# Road & Bridge Design Publications

## Monthly Update – April 2023

Revisions for the month of **April** are listed and displayed below and will be included in projects submitted for the **August** letting.

7.01.55C (continued)

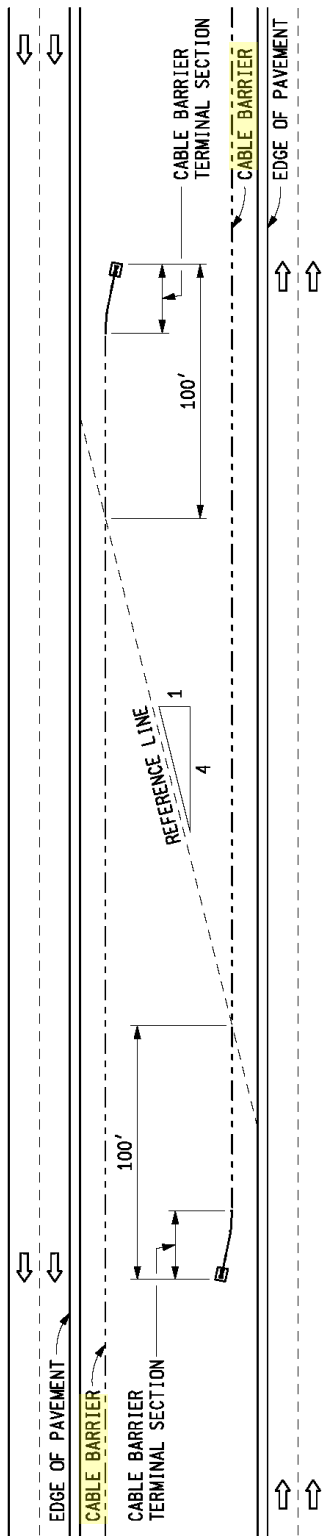
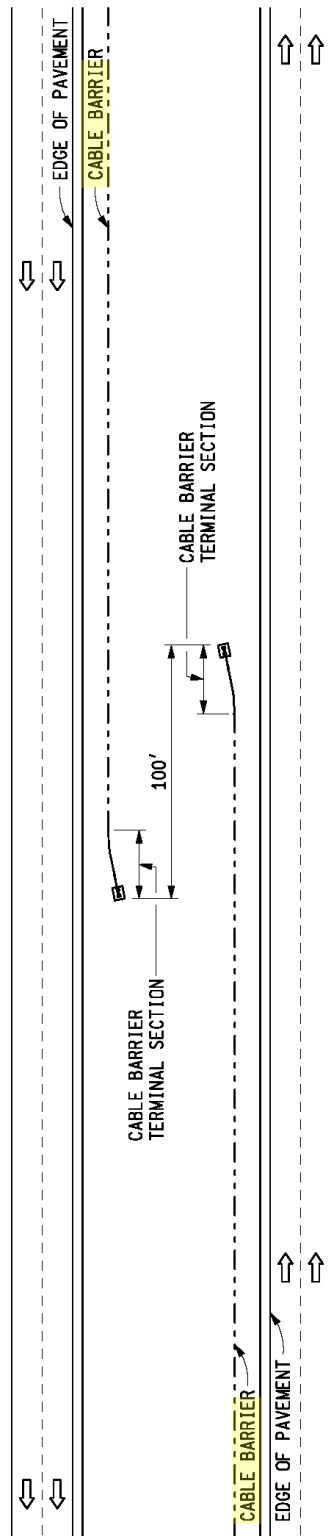
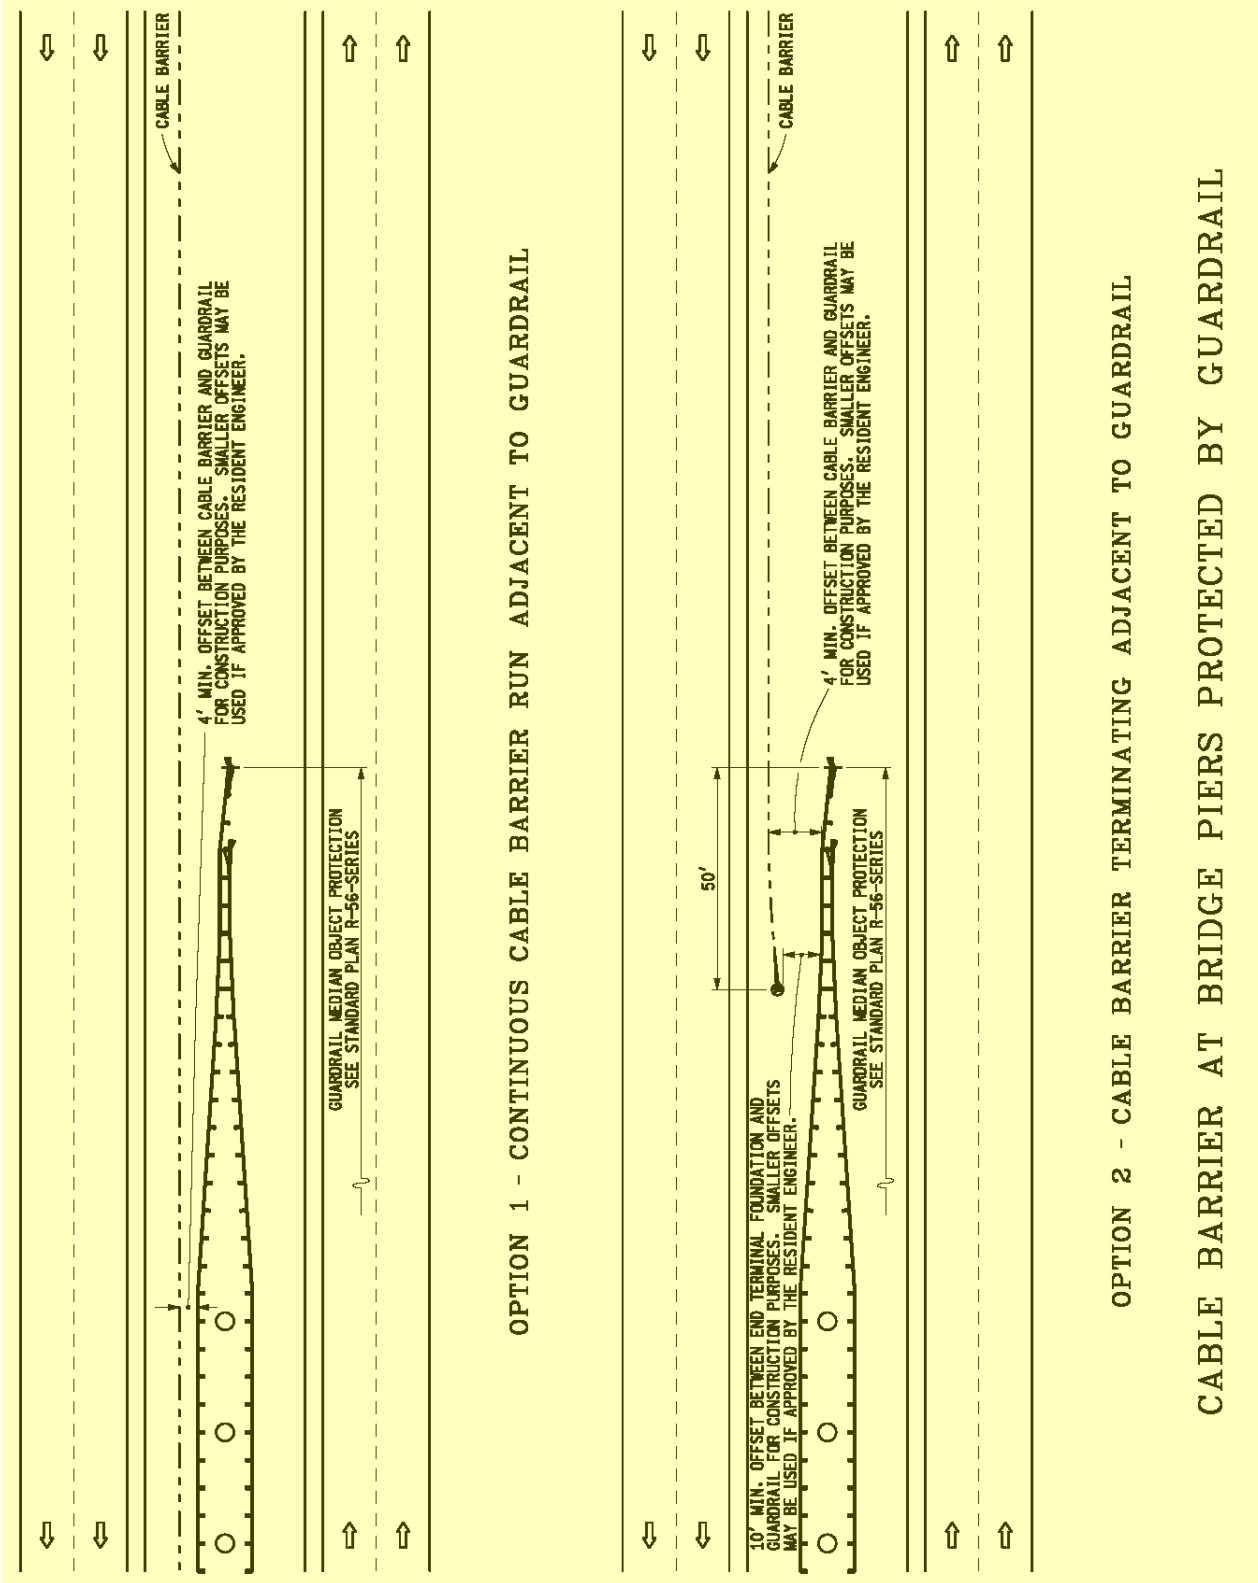
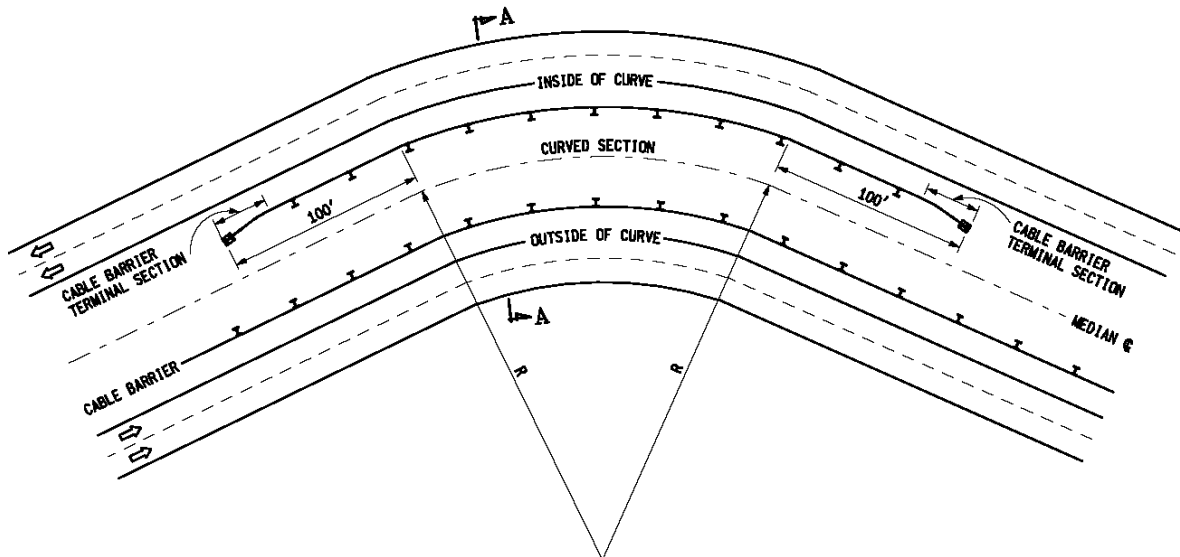
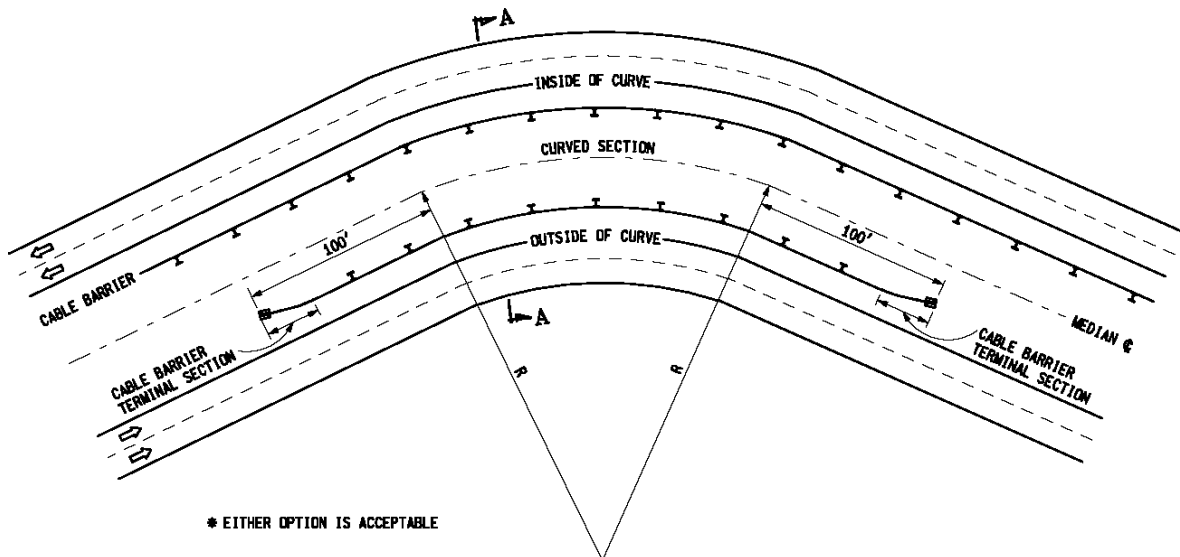
7.01.55C: Cable Barrier: Updated the information on the three proprietary, high tension cable barrier systems. Added text indicating the two-mile maximum length between terminals for high tension cable barrier may be exceeded if approved by the local TSC. Added drawings for “cable barrier at bridge piers protected by guardrail” (one detail for cable barrier adjacent to guardrail and another detail for cable barrier terminating adjacent to guardrail).
